O'Reilly Auto Parts located at 2417 Marksheffel Road in Colorado Springs, CO
Drainage Analysis Letter

PROJECT:
 NEW O'REILLY AUTO PARTS STORE
 2417 MARKSHEFFEL RD.
 COLORADO SPRINGS, CO (C11)
PRE-DEVELOPMENT DRAINAGE PLAN

Drainage Letter_V1.pdf Markup Summary

1 POST-DEVELOPMENT DRAINAGE PLAN
 DR2 SCALE: 1" = 40'-0"

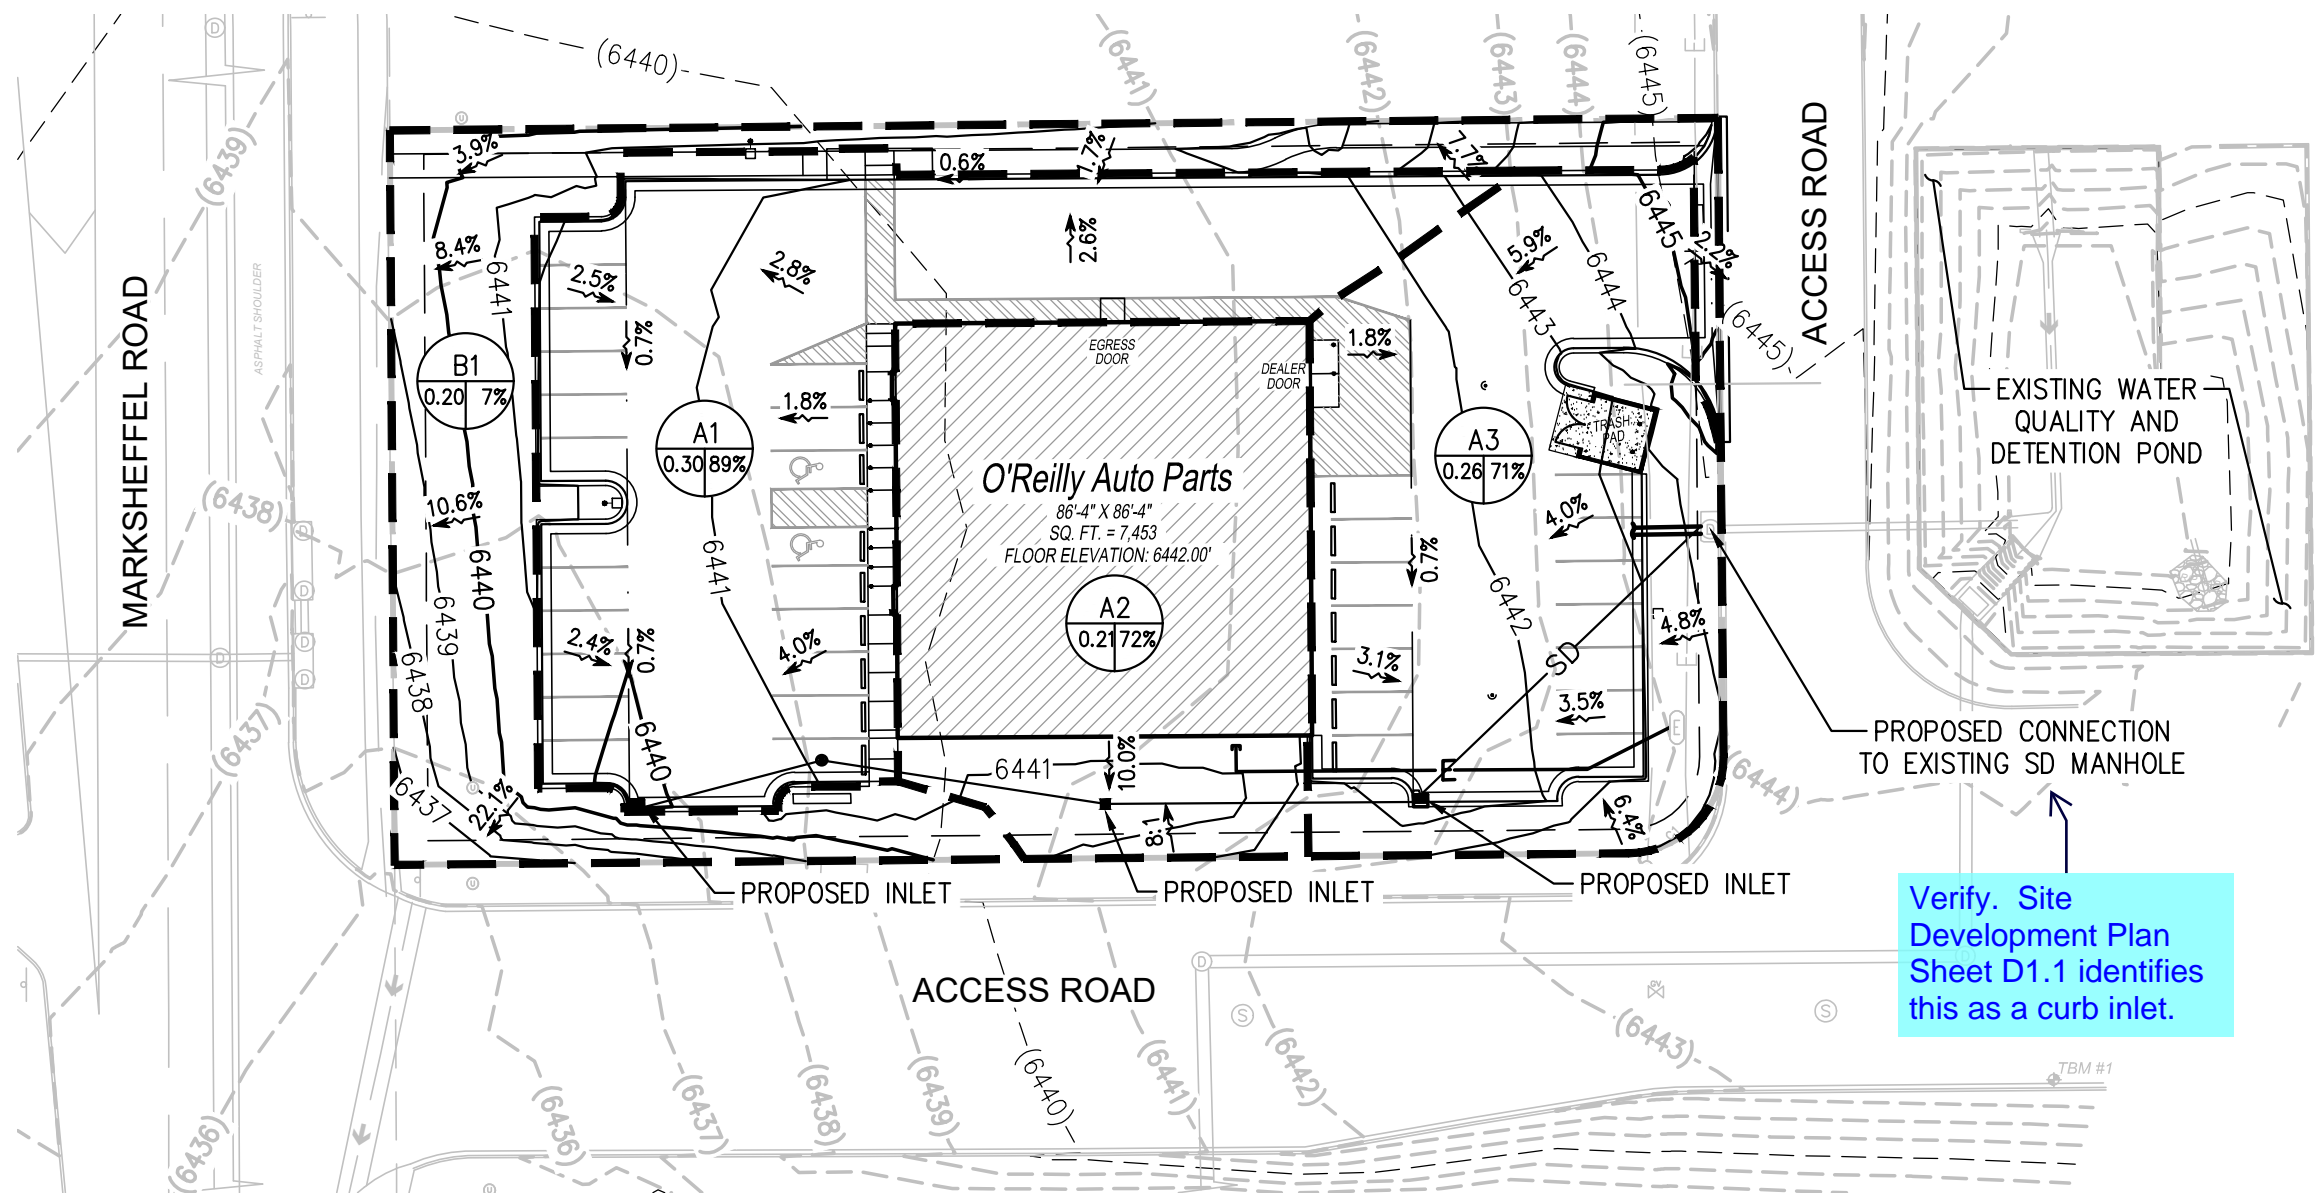
Verify. Site Development Plan Sheet D1.1 identifies this as a curb inlet.
